**ON-SITE SEWAGE DISPOSAL SYSTEM
HOWARD COUNTY HEALTH DEPARTMENT
BUREAU OF ENVIRONMENTAL HEALTH**

04-313518

ADDRESS: 14350 Dorsey Mill Road

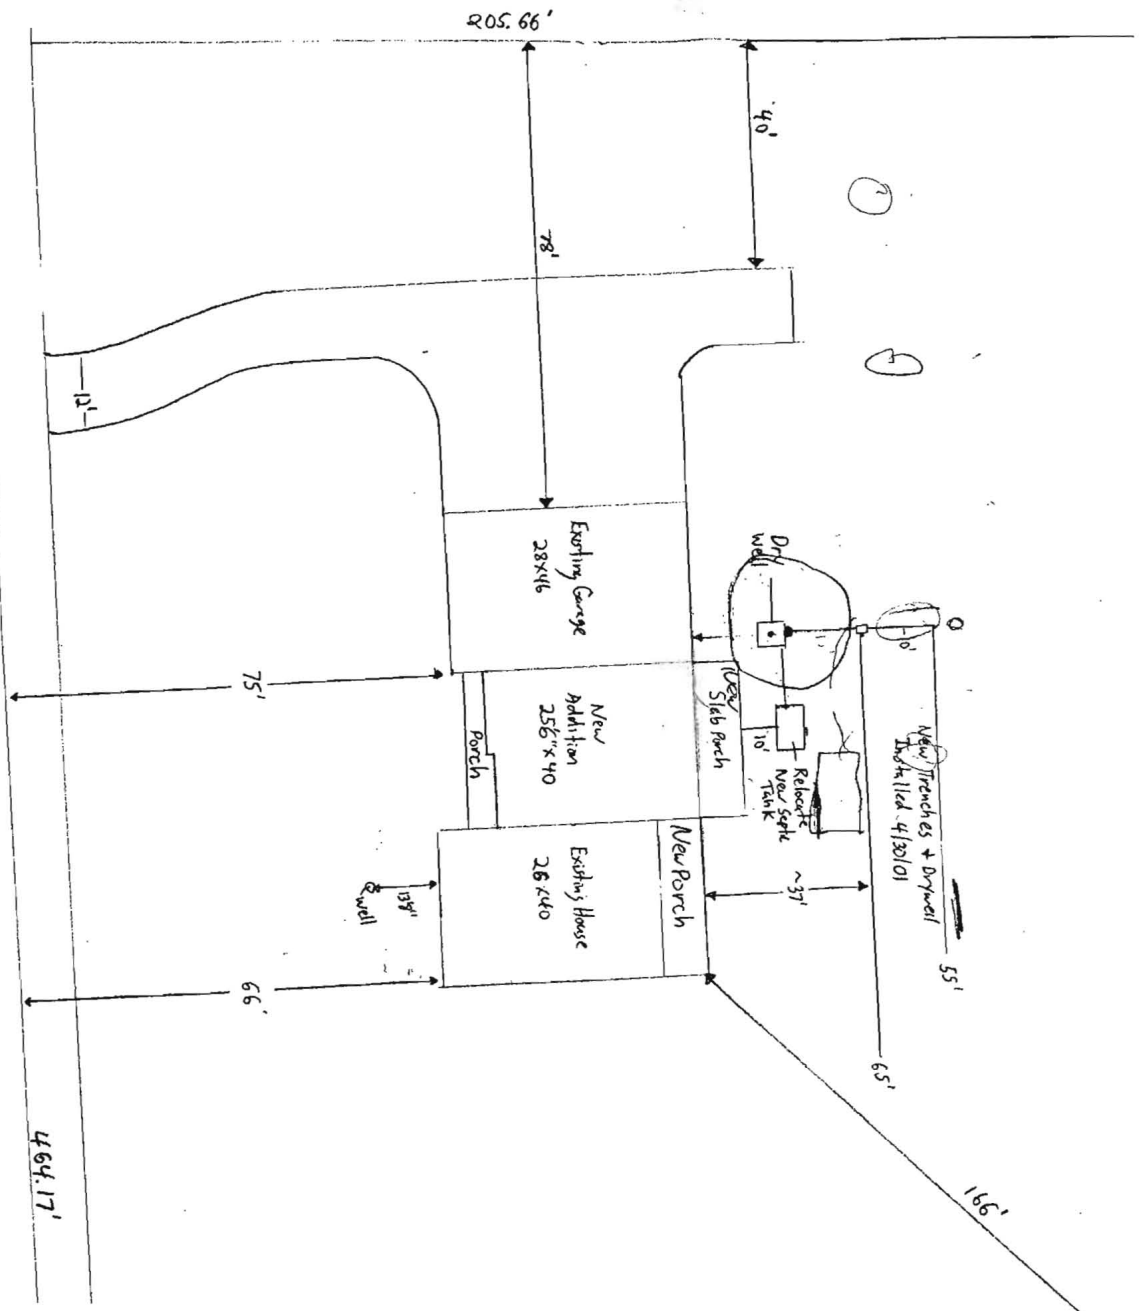
INSTALLATION 6/16/03 New S.T. set, connected to Ex D.W. (SO)

6/23/03 Contr. say home owner will eventually make this a 6 bedroom house so he wants addition trench put in now (SO)

6/24/03 OK to cover all work (SO)

Plot Plan	Scale: 1"=21.33'
14350 Dorsey Mill Rd Glenwood, MD	Date: 3/28/03 By: Richard Hudson

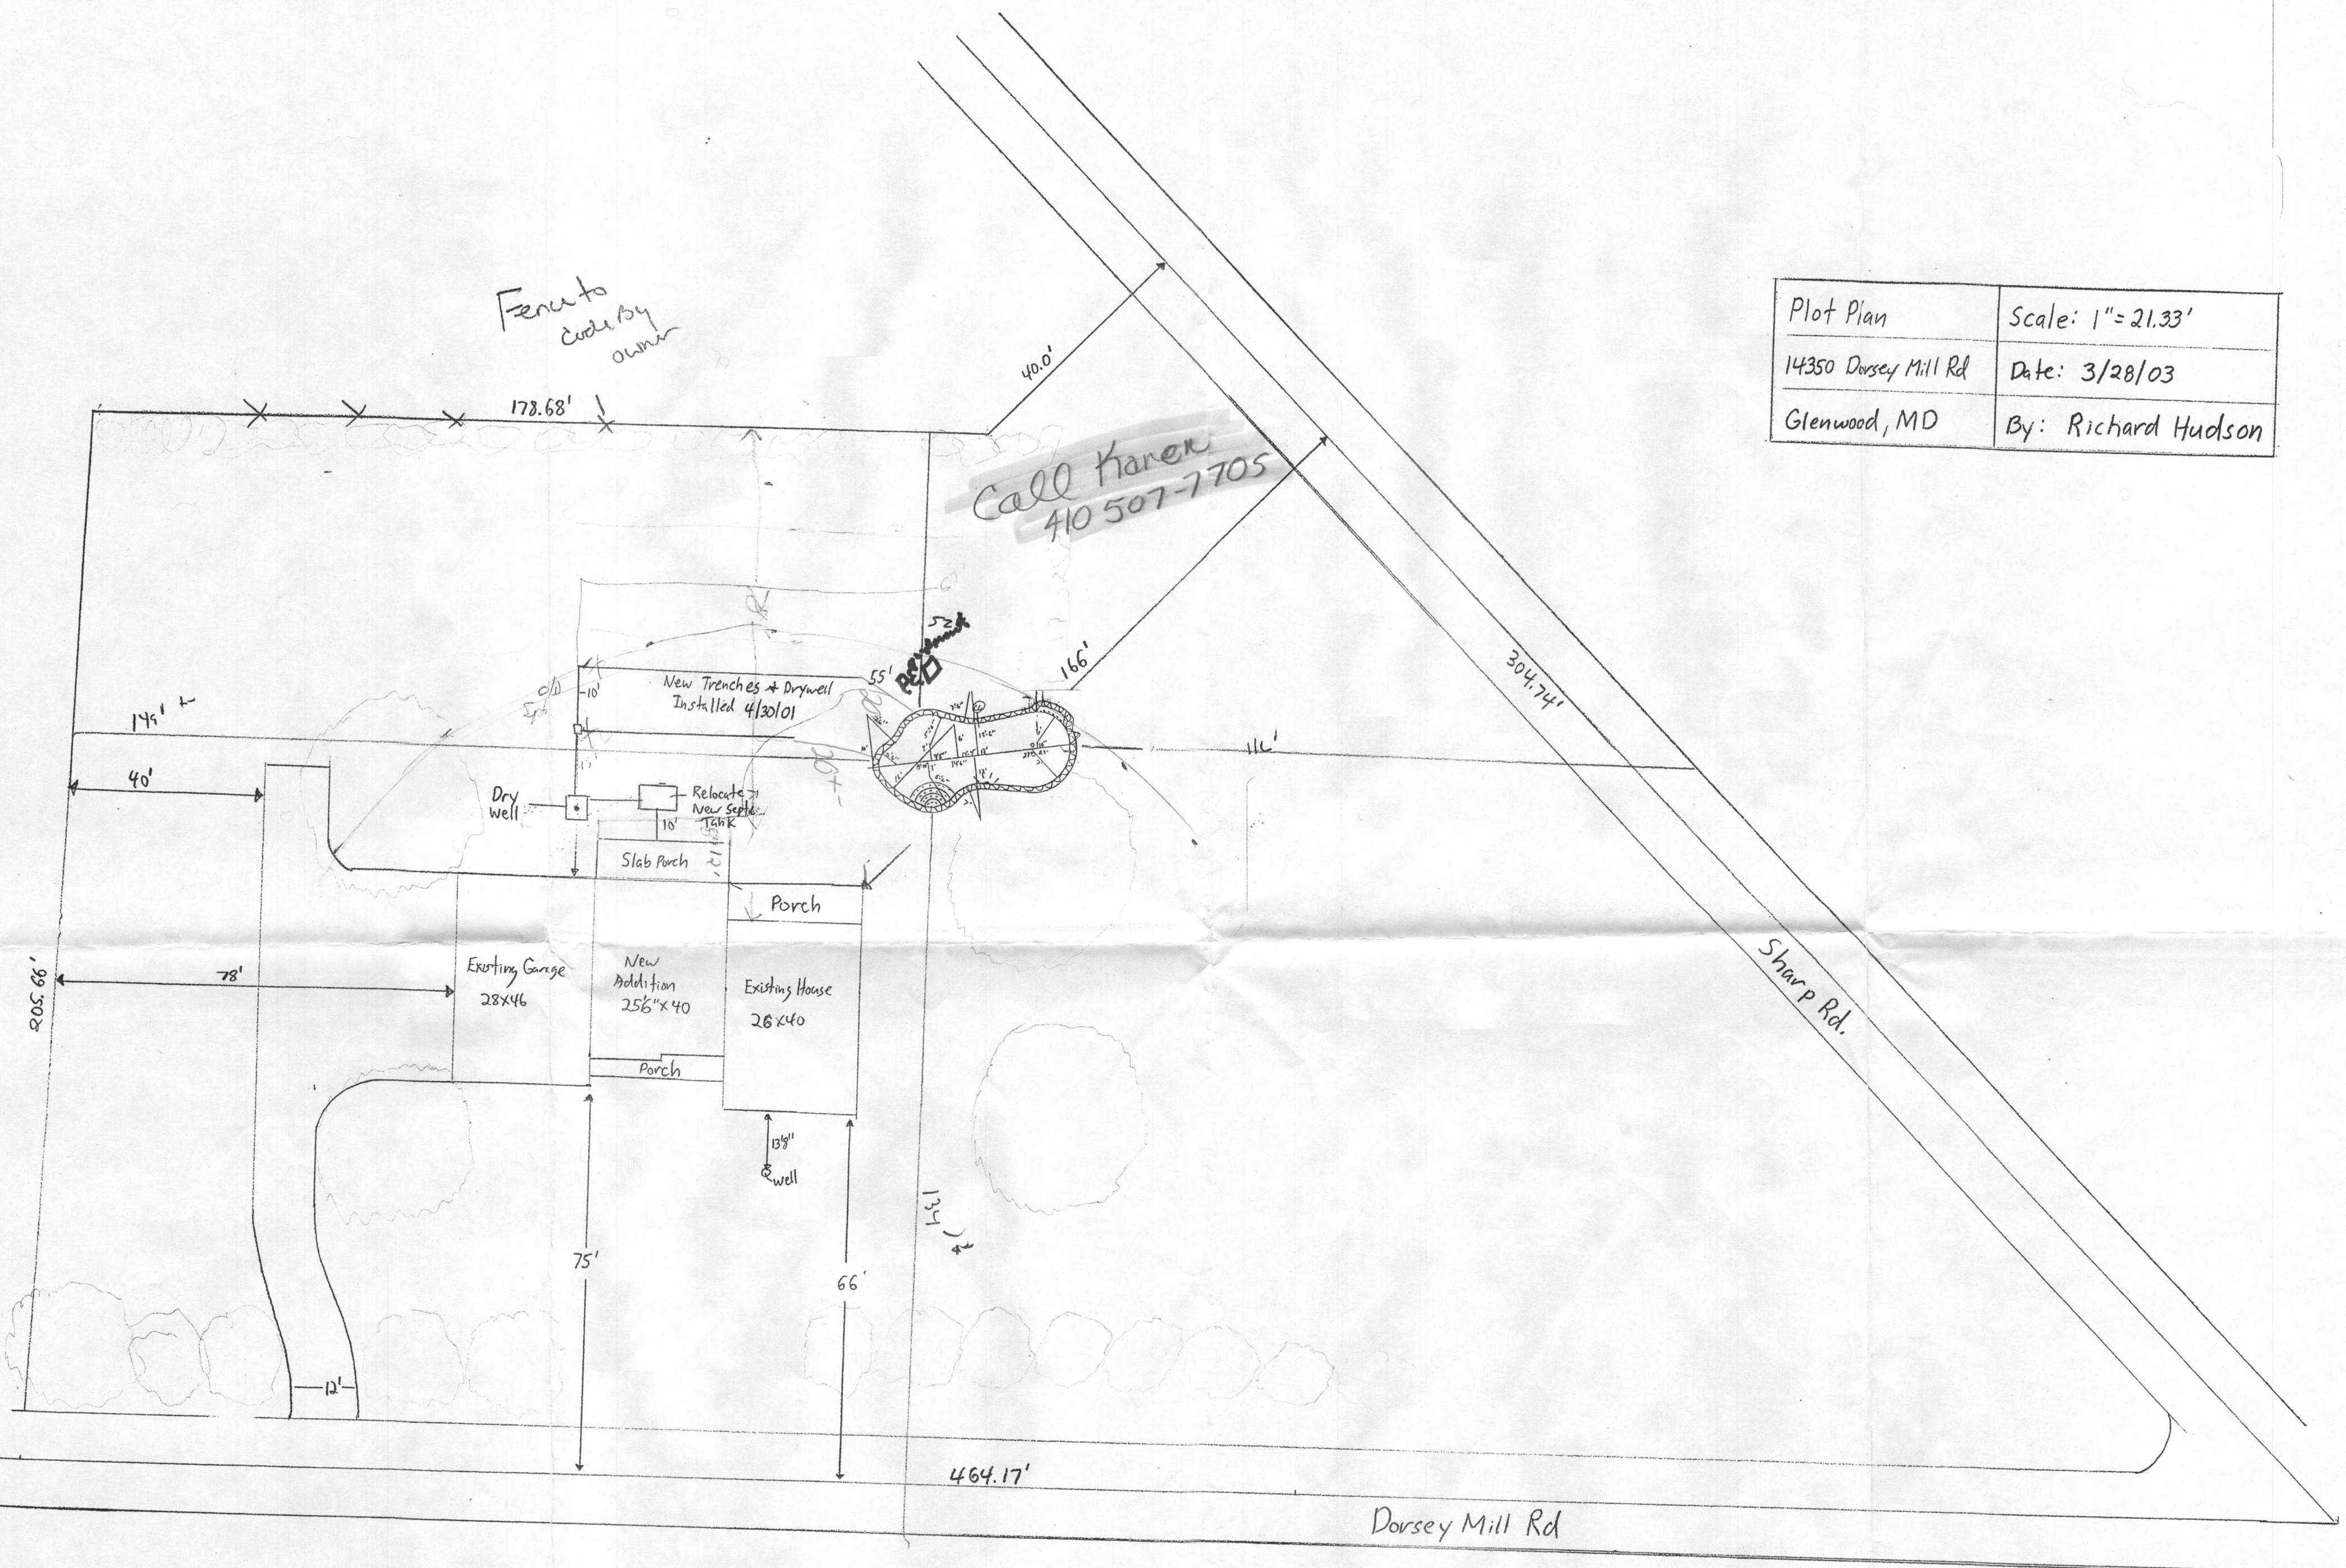
* Note: The ~~Drywell~~ + Trenches were replaced by Fyock Inc. 4/2001.
 Fyock will be contracted to place a new septic tank + fill the old one w/stone. Fyock will obtain this permit.

Plot Plan	Scale: 1" = 21.33'
14350 Dorsey Mill Rd	Date: 3/28/03
Glenwood, MD	By: Richard Hudson

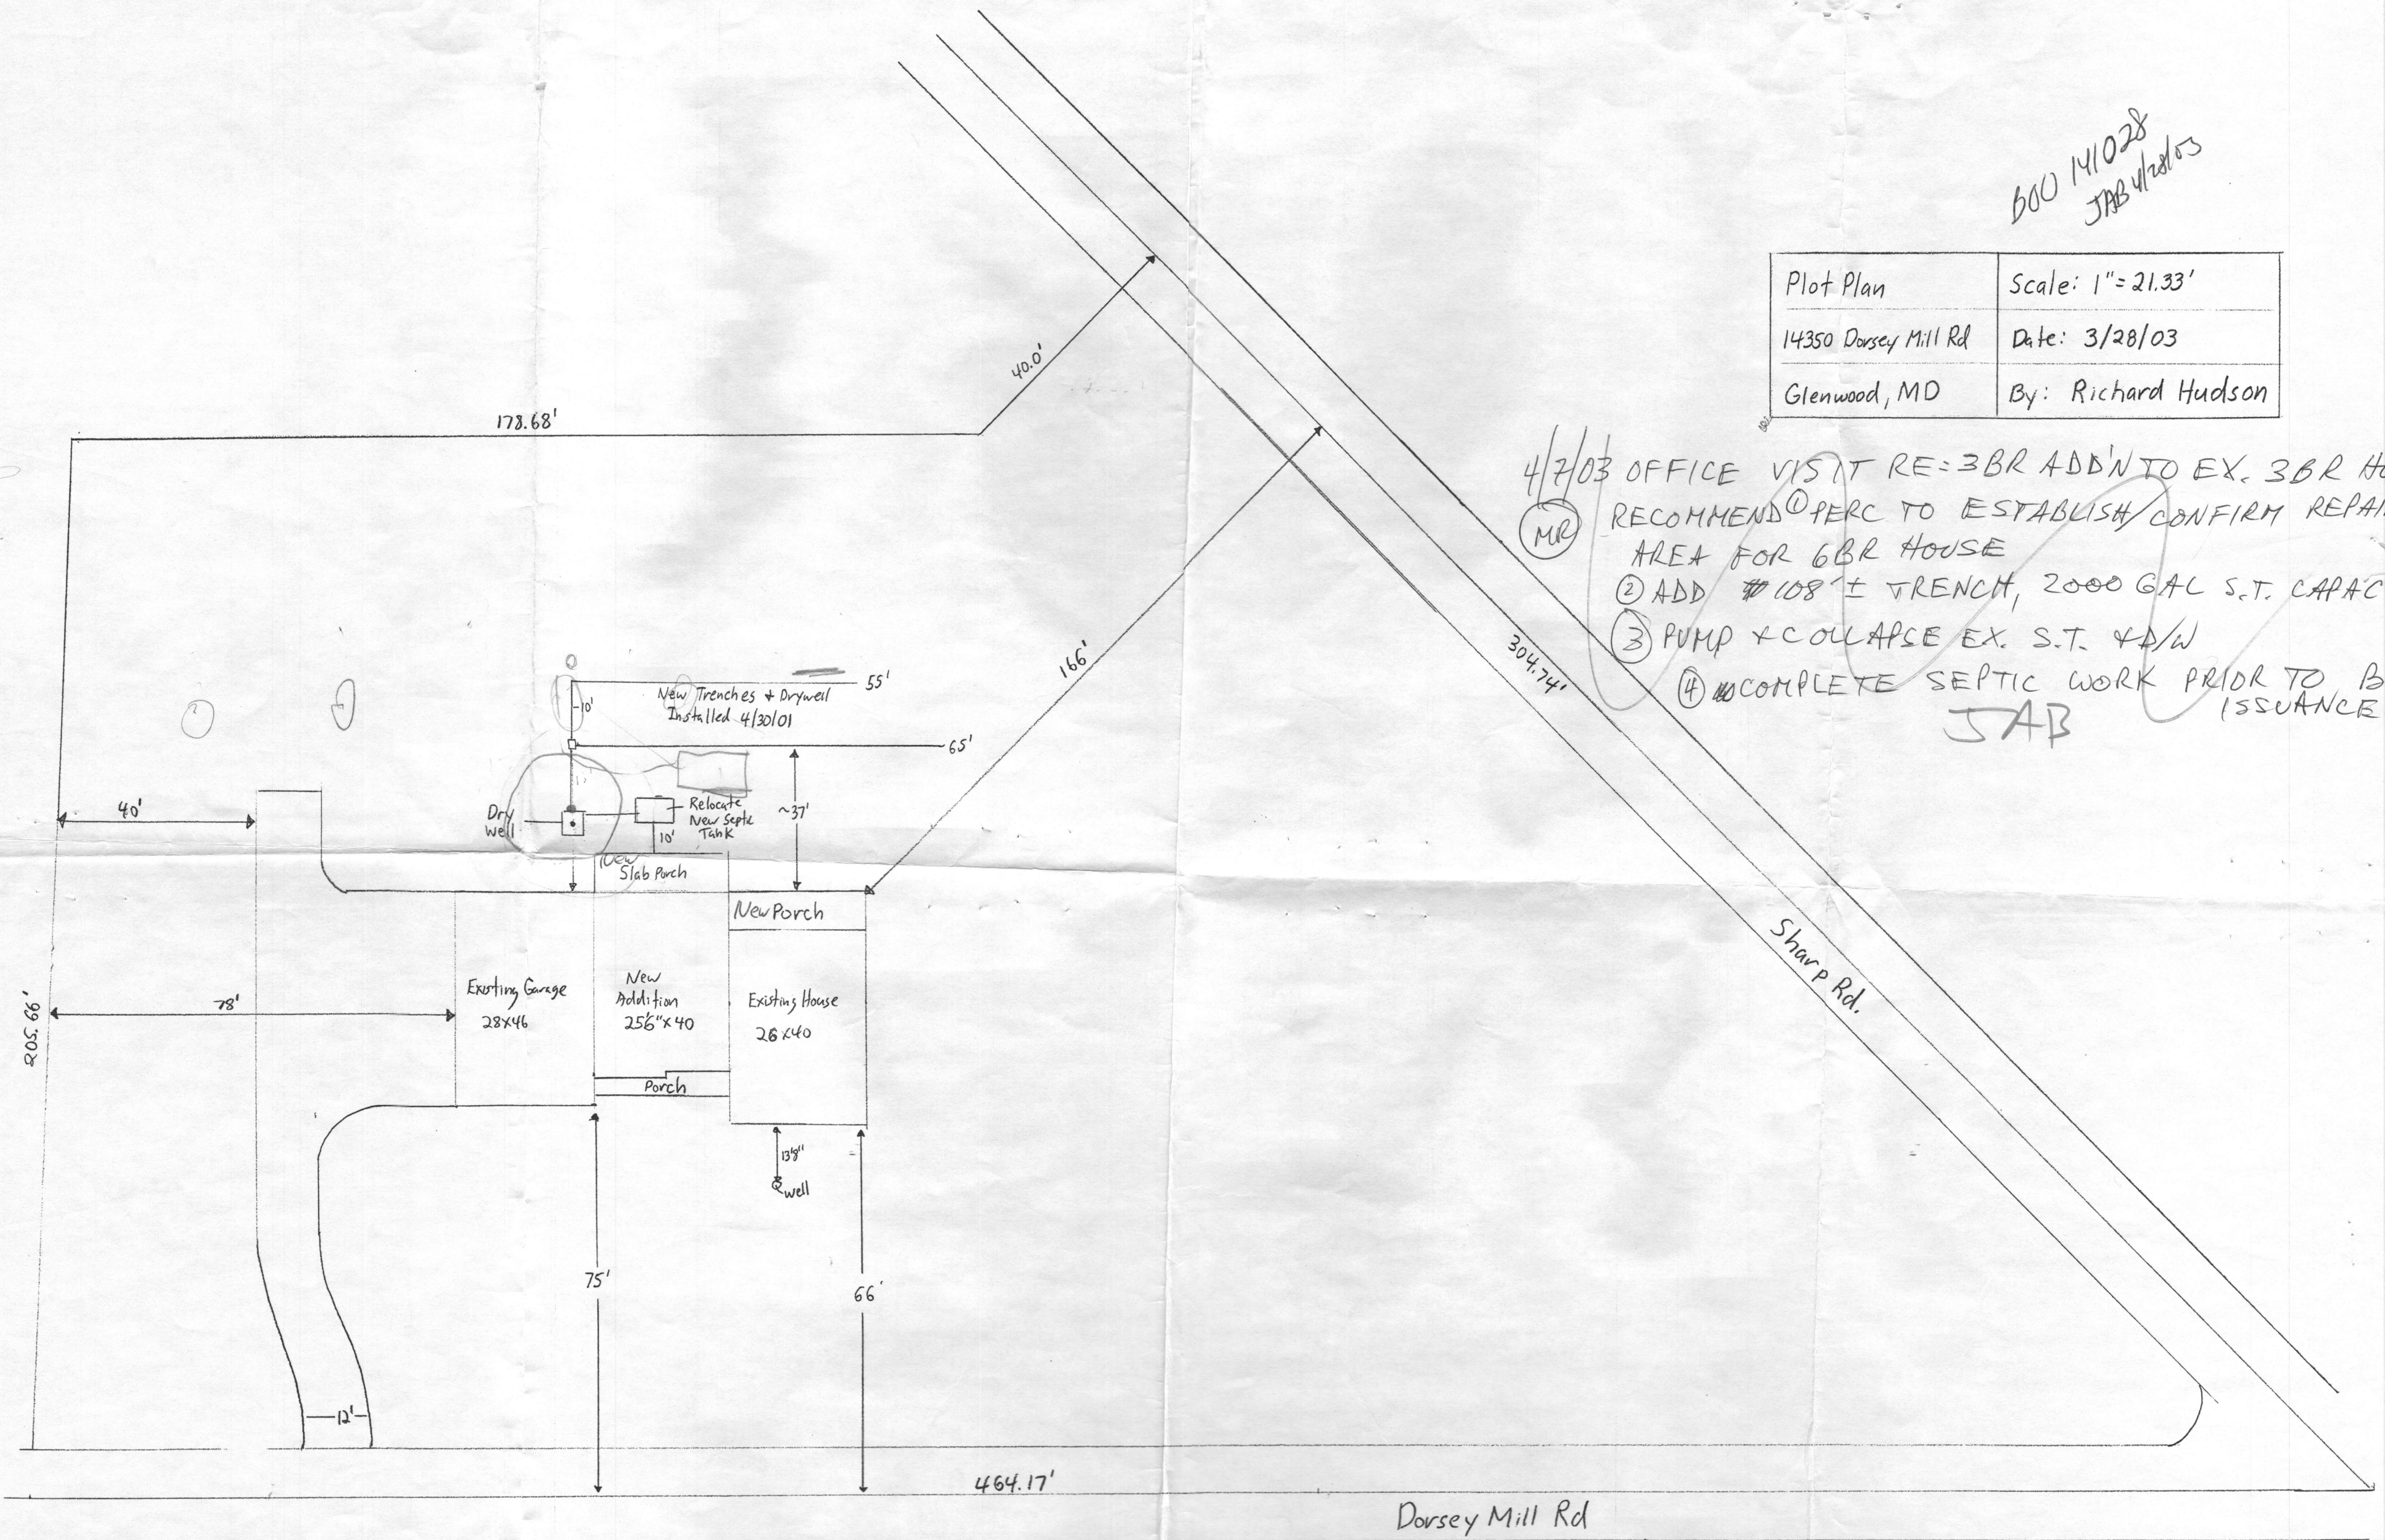
4/7/03 OFFICE VISIT RE: 3BR ADD'N TO EX. 3BR HOUSE
 RECOMMEND ① PERC TO ESTABLISH/CONFIRM REPAIR AREA FOR 6BR HOUSE
 ② ADD 108' ± TRENCH, 2000 GAL S.T. CAPACITY
 ③ PUMP + COLLAPSE EX. S.T. 4D/W
 ④ COMPLETE SEPTIC WORK PRIOR TO BP ISSUANCE
 JAB
